**Response to Consultation Document for
the Regulatory Authority of Bermuda
Regarding Bermuda's 2018 IRP**

2 July 2018

Regulatory Authority of Bermuda
Response to Consultation Document 2018 05 02
(Integrated Resource Plan Proposal Consultation)

Figure 2.1 – NPV Summary of LCOE Analysis Results

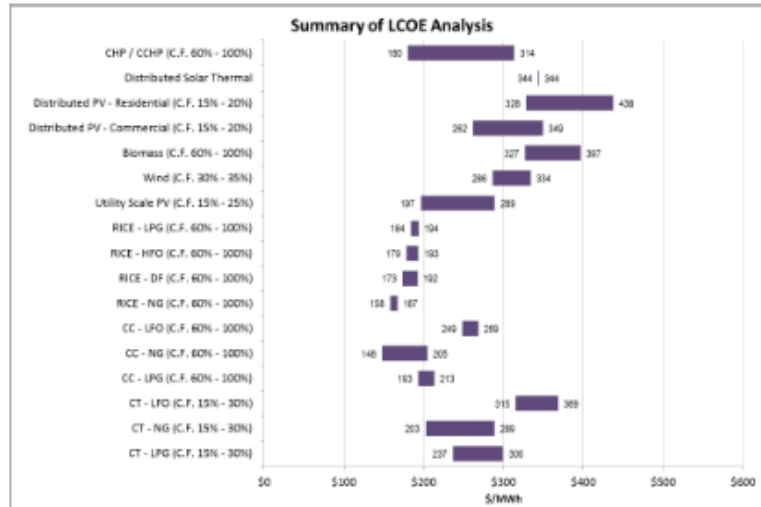
Also, it is apparent in their analysis that the LCOE (levelized cost of energy) calculation of utility scale solar is too high and our research shows a similar mistake for distributed solar which makes their analysis of wind and bio-mass suspect as well. However, given the ability to directly monitor their generating plant, we have confidence that they have calculated the correct LCOE for their gas turbine “peakers” (shown as CT – LFO above).

As we see from the Finger project, utility scale solar is more than three times less expensive than traditional peak demand resources. Coupled with battery storage, solar is competitive with gas turbine peaker plants without incurring the “public health added cost” associated with burning fuel oil.

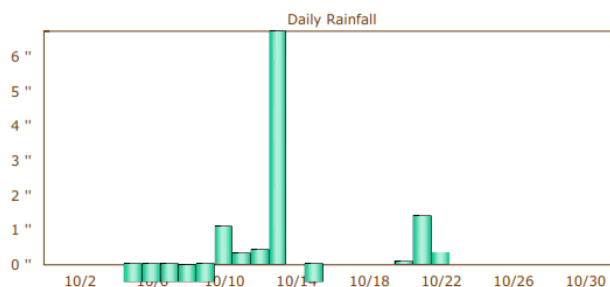
Last year we saw a series of extreme tides, most notably the 18th October 2017, "King Tide", a confluence of highest astronomical tide (HAT) and a warm water eddy, that flooded Town Square and would have put the NPS site under 18" of water.

HAT is 2.6 feet above the ordinance survey (OS) datum. The warm water eddy put the water level another 1.5 feet above HAT for a combined 3.1 feet above OS datum. See NOAA tide data Appendix I

Figure 6 – Energy Forecast

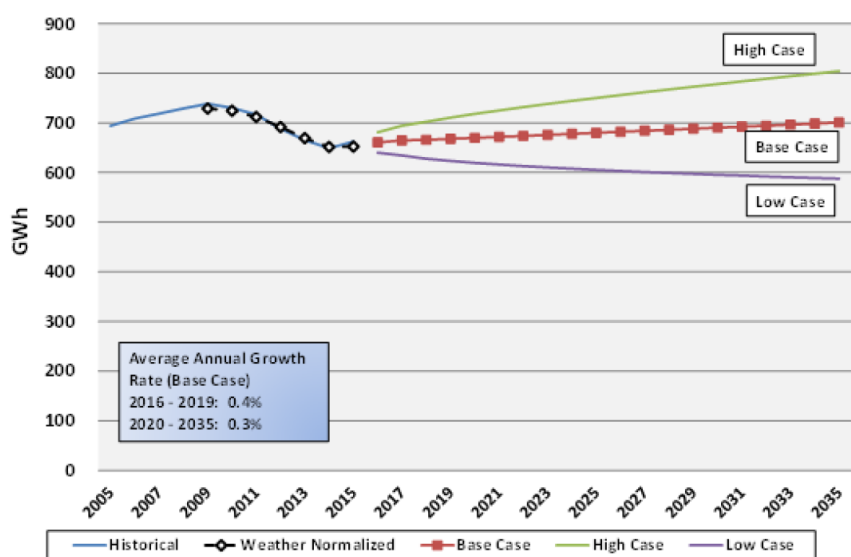
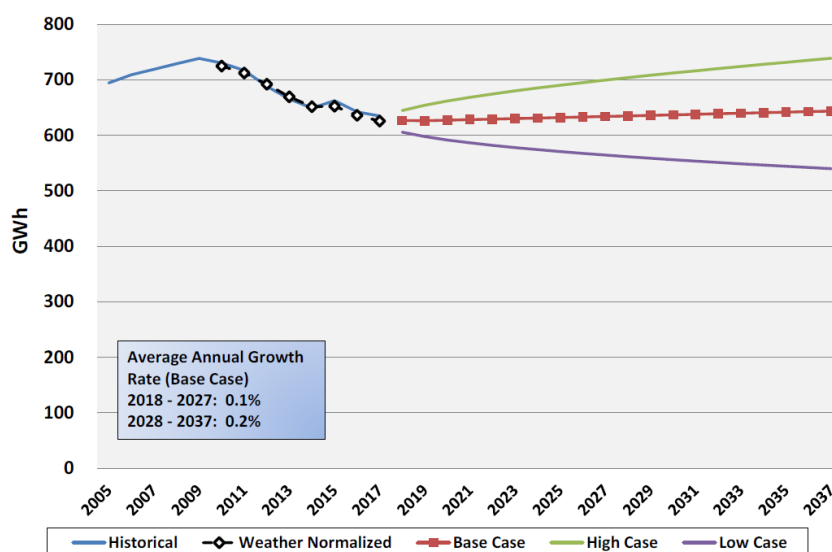
There is no rationale provided by BELCO for this reduction in demand. To justify such a relative reduction in demand for electricity over the lifetime of the IRP, BELCO should provide substantial credible macro-economic analysis. It did not do so. In its place, it has made an assumption of zero % GDP growth for the entire twenty-year period of the IRP (see Appendix ID2 of the IRP proposal). In the 2016 version of the IRP, BELCO provided more detailed analysis of the Bermuda economy to support what was a higher demand forecast.

Figure 1.3 – Base Case Commodity Price Forecast

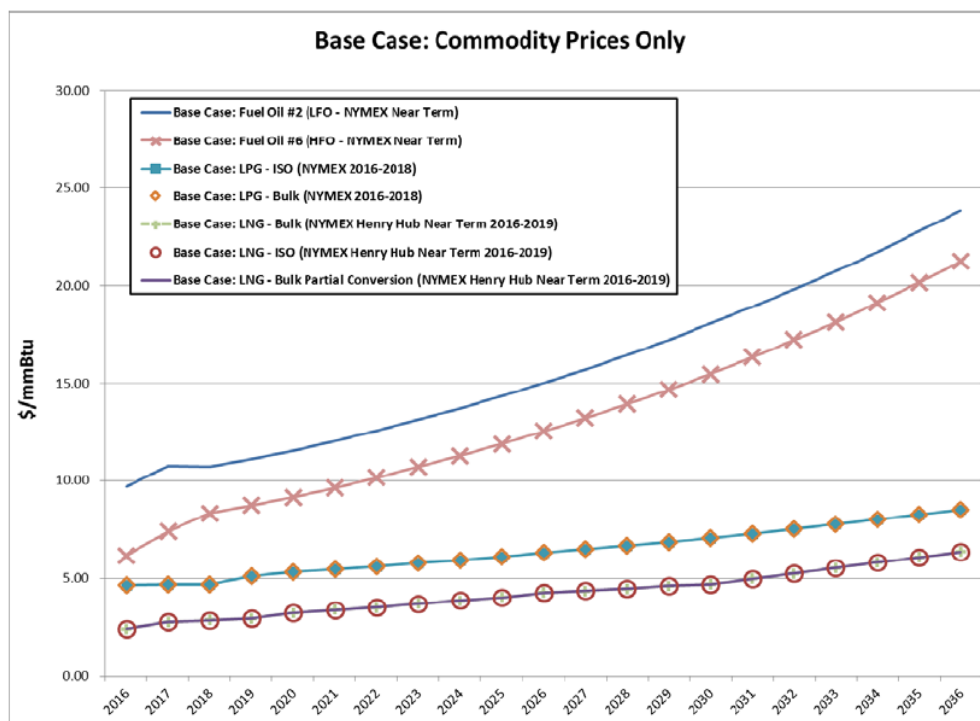
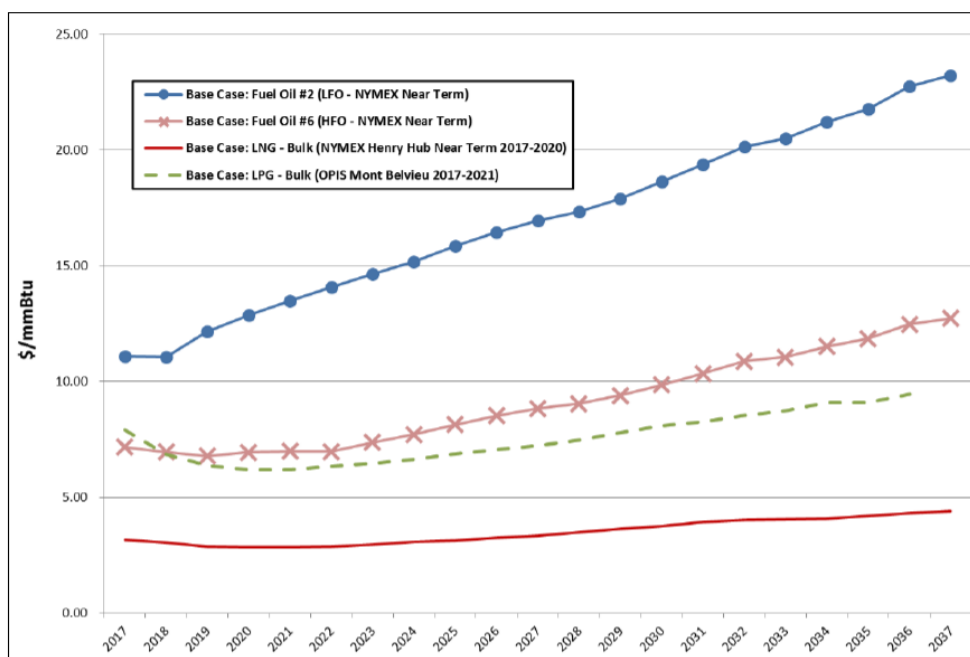
BELCO forecasts significantly lower fuel costs in the IRP proposal than it does in the 2016 IRP (see below).

There is no explanation by BELCO for this downward revision in the fuel costs. BELCO notes the use of an ‘independent consultant’ (Section 1.5 of the IRP proposal) but provides no detail on the consultant or the basis of the output from this entity. As well as being at variance with the fuel cost forecasts that BELCO provided in the 2016 IRP, it is notable that BELCO’s forecast for natural gas:

Figure 2.1 – NPV Summary of LCOE Analysis Results

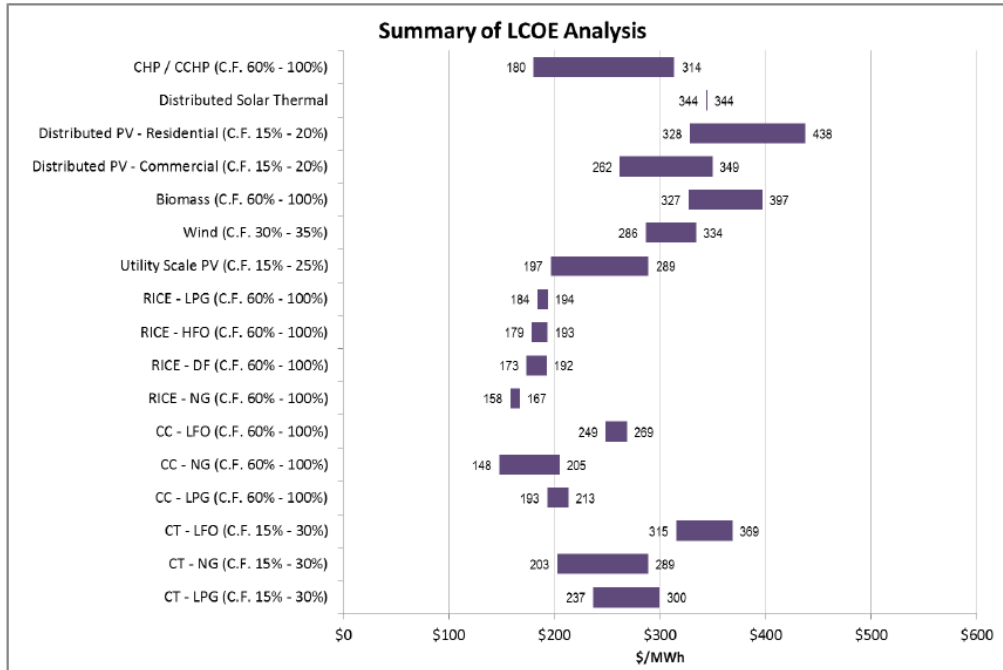
In Section 2.4 of the IRP proposal (figure 2.1), BELCO provides a limited sensitivity analysis of potential LCOE output values (not of sensitivity within a LCOE value itself) for which we would observe the following:
